# **As-built Baseline Monitoring Report**

**Mill Dam Creek Restoration Site  
Yadkin River Basin - 03040101  
Monitoring Year 00  
DEQ Contract 6898  
DMS Project Number 97136**

## MEMORANDUM

Subject: Mill Dam Creek Stream Restoration Site  
MY-00 Monitoring Report Comments  
Yadkin River Basin CU 03040101  
NCDMS Project # 97136  
Contract # 6898

**Current Conditions Plan View**  
**Mill Dam Creek Restoration Site**  
**DMS Project #97136**  
**Yadkin County, NC**  
**Overview Page**

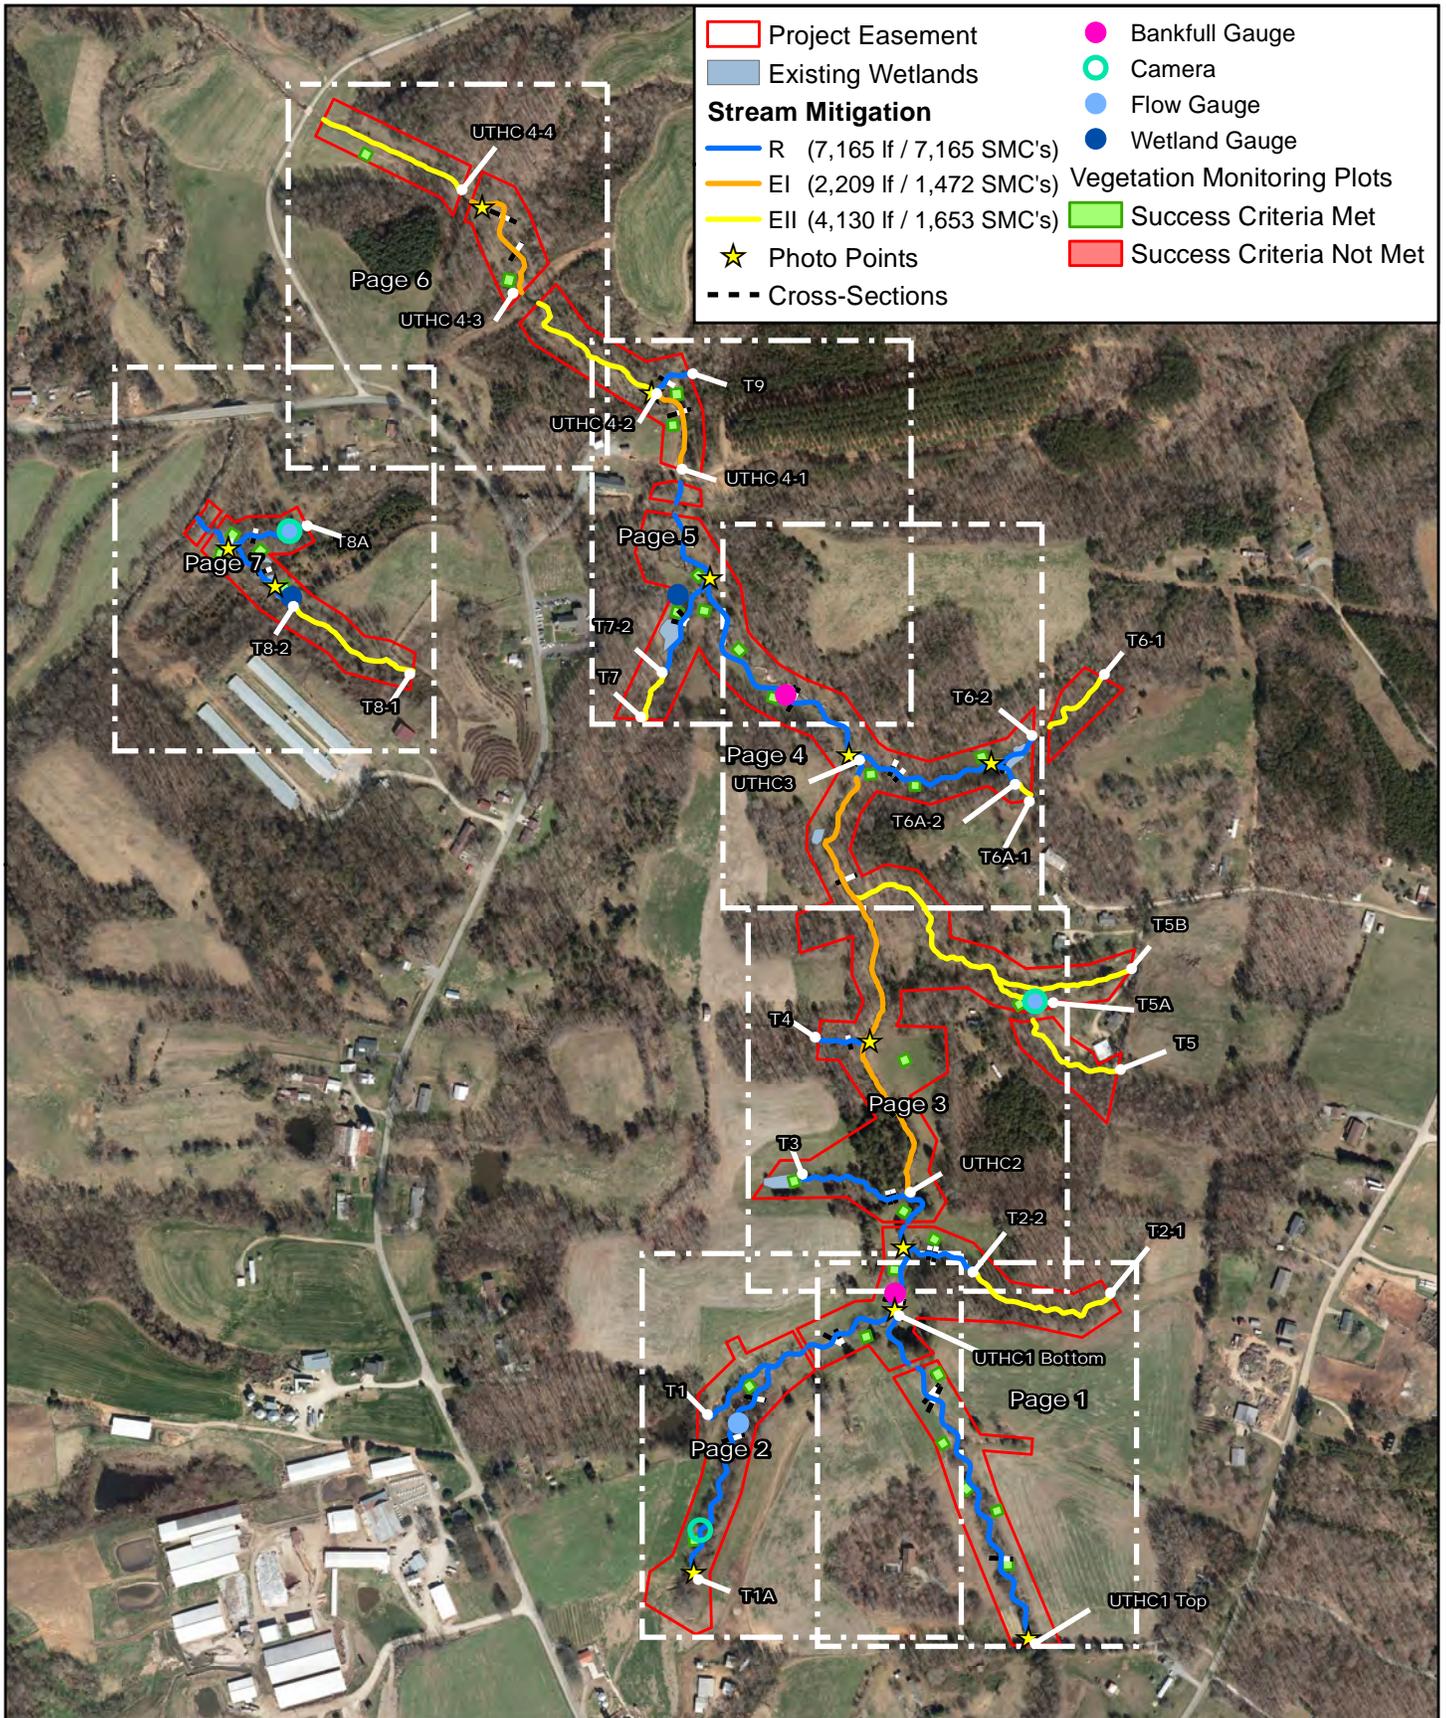
- CCPV: The project overview page did not print correctly in the hard copy and also displays an error in the digital copy. Please verify it is shown and opens correctly for the final.  
*KCI Response: It appears that the large file size of the PDF was causing an error. KCI has created a PDF of smaller file size for use in the report. A separate georeferenced PDF is now included in the digital deliverables.*

- CCPV: Please label stream reaches.  
*KCI Response: This change has been made.*

Longitudinal Profile  
Mill Dam Creek - UTHC-1  
Monitoring Year 00, 2020

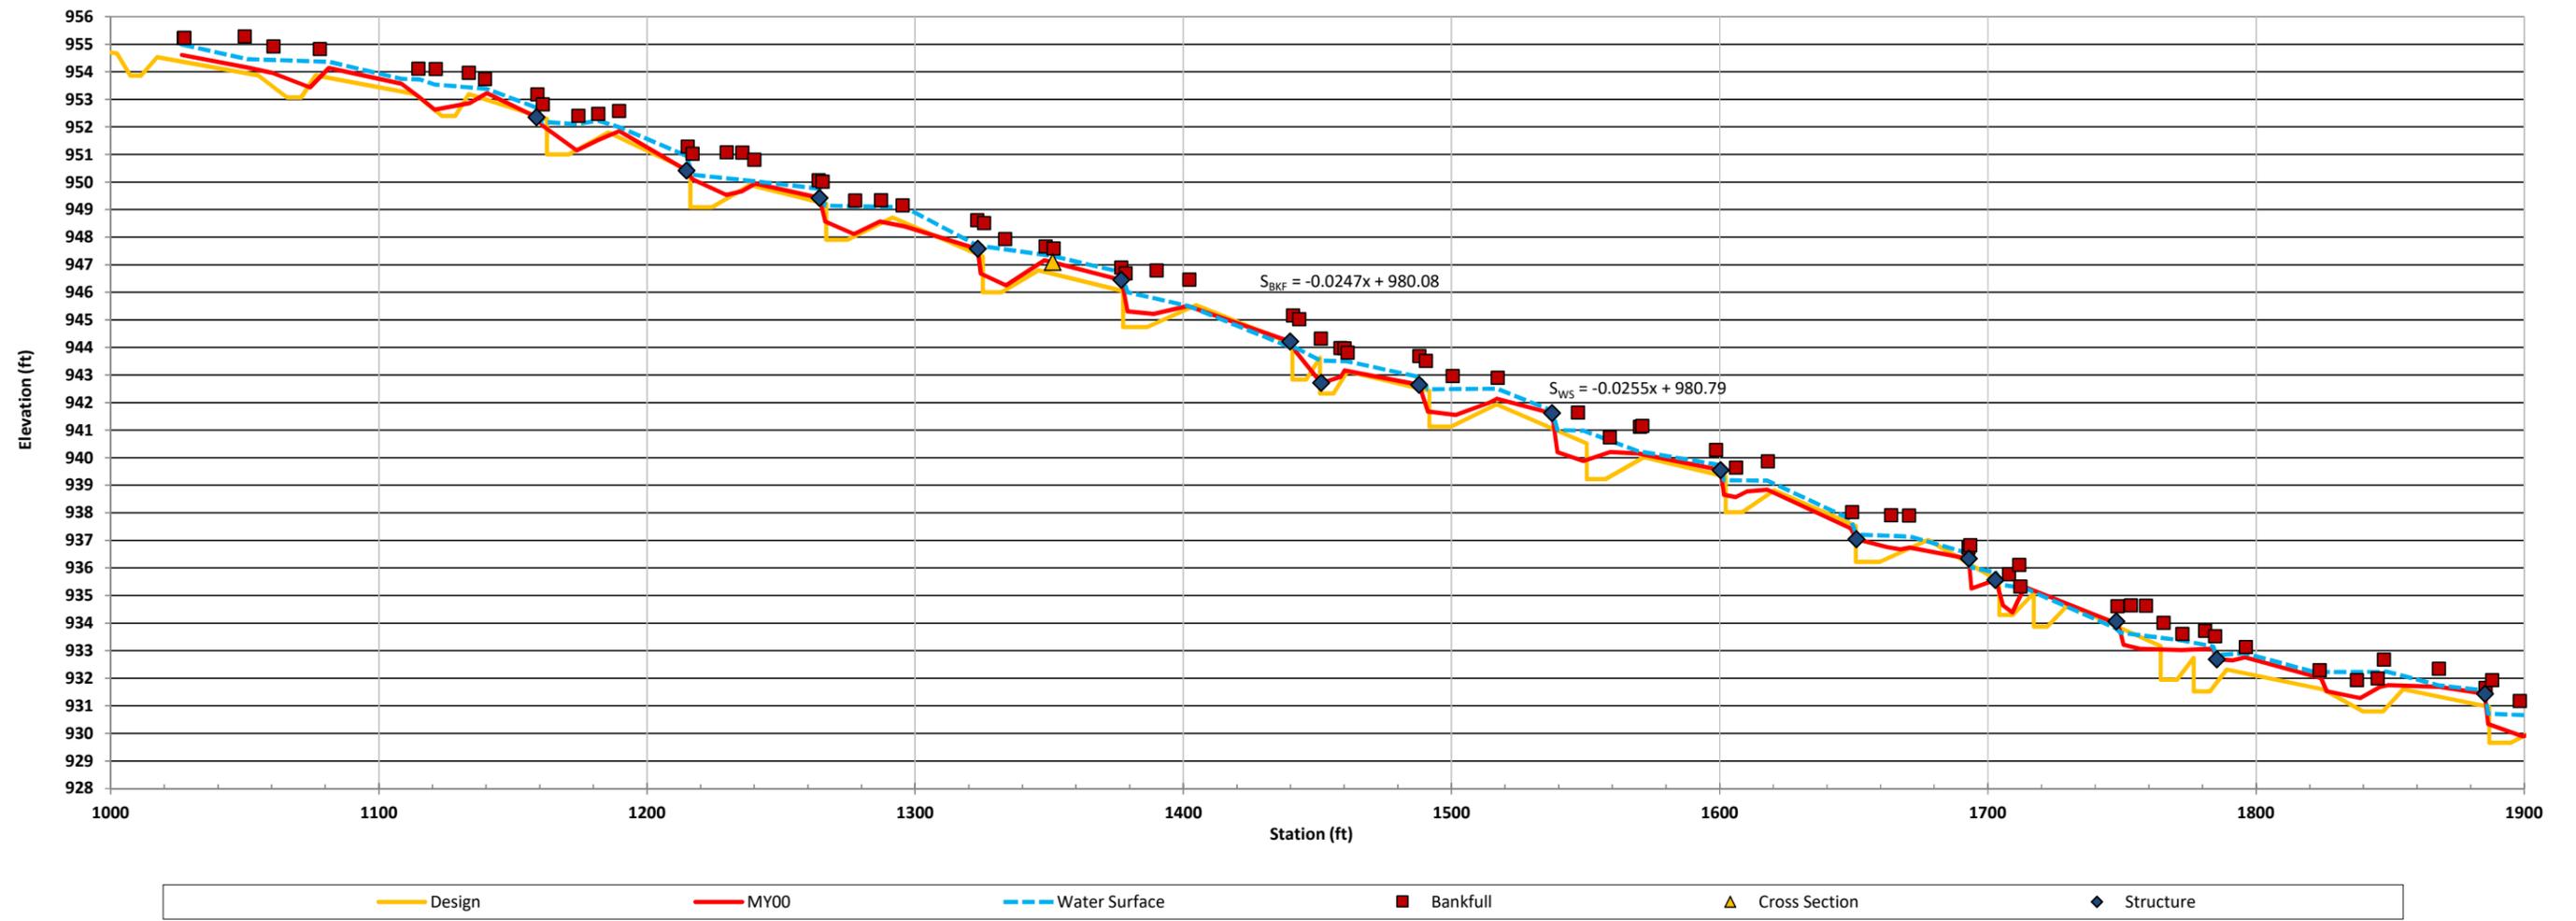
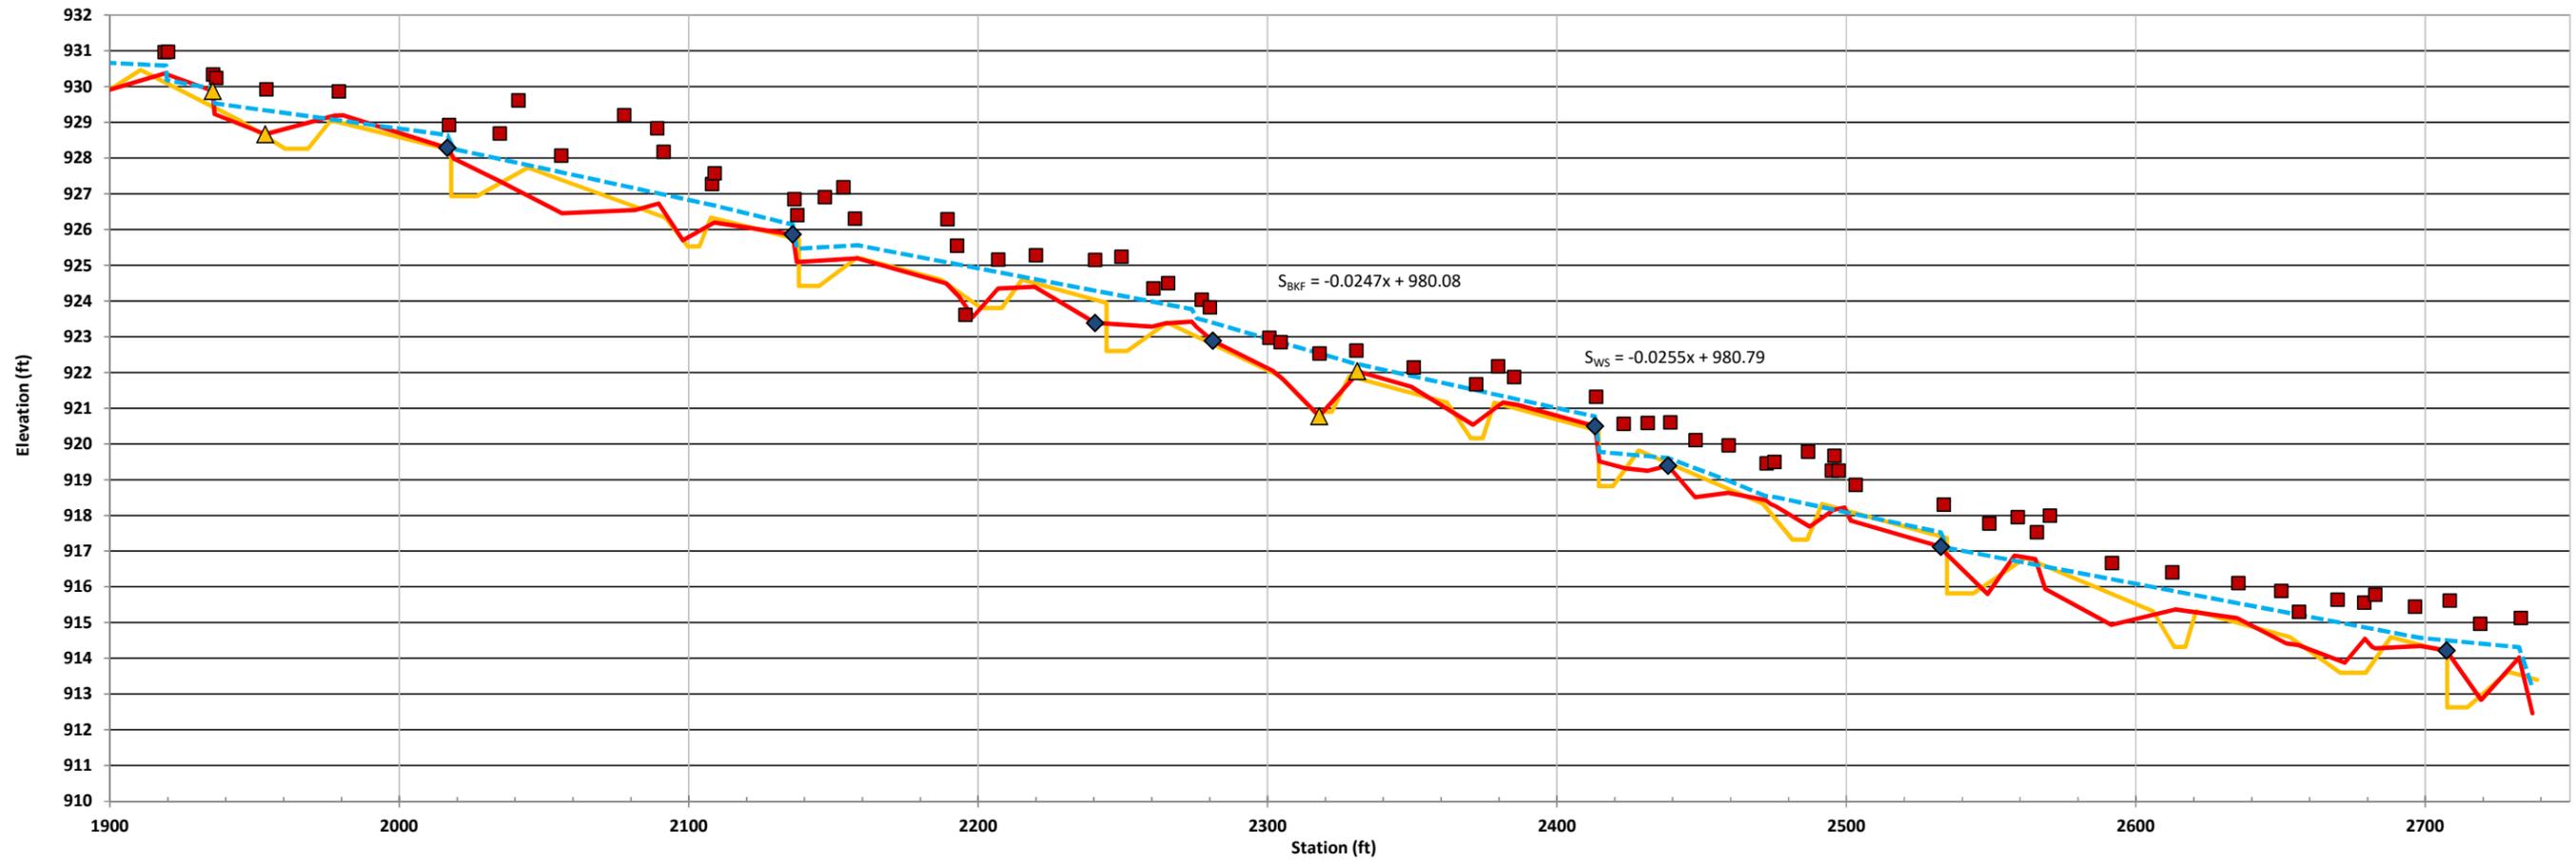
- Profile: There are many instances where the water surface profile does not follow the riffle/pool geometry of the channel (UTHC-1, T1, T1A, T3). Is this a result of a lack of survey data, does the water go subsurface or something else?  
*KCI Response: Looking back at the data, the as-built profile did not include as many water surface shots as we would have liked. KCI will work with our surveyor to make sure that more water surface shots are taken in future as-built surveys. There are no areas on the project where the water goes subsurface.*
